Project	IEEE 802.16 Broadband Wireless Access Working Group < http://ieee802.org/16 >	
Title	R-FCH for Relay Zone	
Date	2007-04-25	
Submitted		
Source(s)	Kanchei (Ken) Loa, Yi-Hsueh Tsai, Yung-Ting Lee, Hua-Chiang Yin, Shiann-Tsong Sheu, Youn-Tai Lee, Frank C.D. Tsai, Chih-Chiang Hsieh, Heng-Iang Hsu Institute for Information Industry 8F., No. 218, Sec. 2, Dunhua S. Rd., Taipei City, Taiwan.	Voice: +886-2-2739-9616 loa@iii.org.tw
	[add co-authors here]	
Re:	IEEE 802.16j-07/013: "Call for Technical Comments Regarding IEEE Project 802.16j"	
Abstract	This contribution provides R-FCH	
Purpose	Text proposal for 802.16j Baseline Document	
Notice	This document has been prepared to assist IEEE 802.16. It is offered as a basis for discussion and is not binding on the contributing individual(s) or organization(s). The material in this document is subject to change in form and content after further study. The contributor(s) reserve(s) the right to add, amend or withdraw material contained herein.

R-FCH for Relay Zone

Figure 3a OFDMA FCH allocation for all FFT sizes except 128

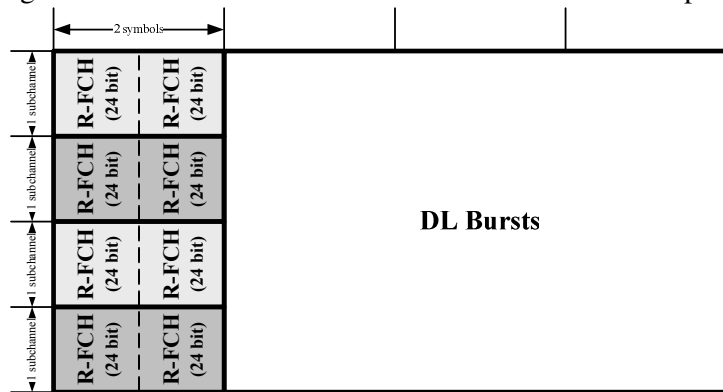
In IEEE 802.16j-026r3, there are three issues in section 8.4.4.7.3 R-FCH channel:

- (1) The subchannel allocation of R-FCH in RS_Zone with FUSC or AMC permutation is not defined
- (2) FEC Code type and modulation type is not flexible enough.
- (3) RS-Zone prefix format for 128 FFT is not defined whose length is only 12 bits.

If RS_Zone is FUSC or AMC permutation, the R-FCH shall be allocated as follows. For FFT sizes other than 128, the first 4 slots in the downlink part of subchannel contain the R-FCH. These slots contain 48 bits modulated by QPSK with coding rate 1/2 and repetition coding of 4. For FFT-128, the first slot in the downlink part of the subchannel is dedicated to R-FCH and repetition is not applied. Figure 3d depicts this structure.

The R-FCH shall be transmitted using QPSK rate 1/2 with four repetitions using the mandatory coding scheme (i.e., the R-FCH information will be sent on four subchannels with successive logical subchannel numbers). For FFT sizes other than 128, **the 24-bit DL Frame Prefix shall be duplicated to form a 48-bit block**, which is the minimal FEC block size. For the case of 128 FFT, the following compressed format shall be used for R-FCH. Before being mapped to the R-FCH, **the 12-bit DL Frame Prefix shall be repeated four times to form a 48-bit block**, which is the minimal FEC block size.
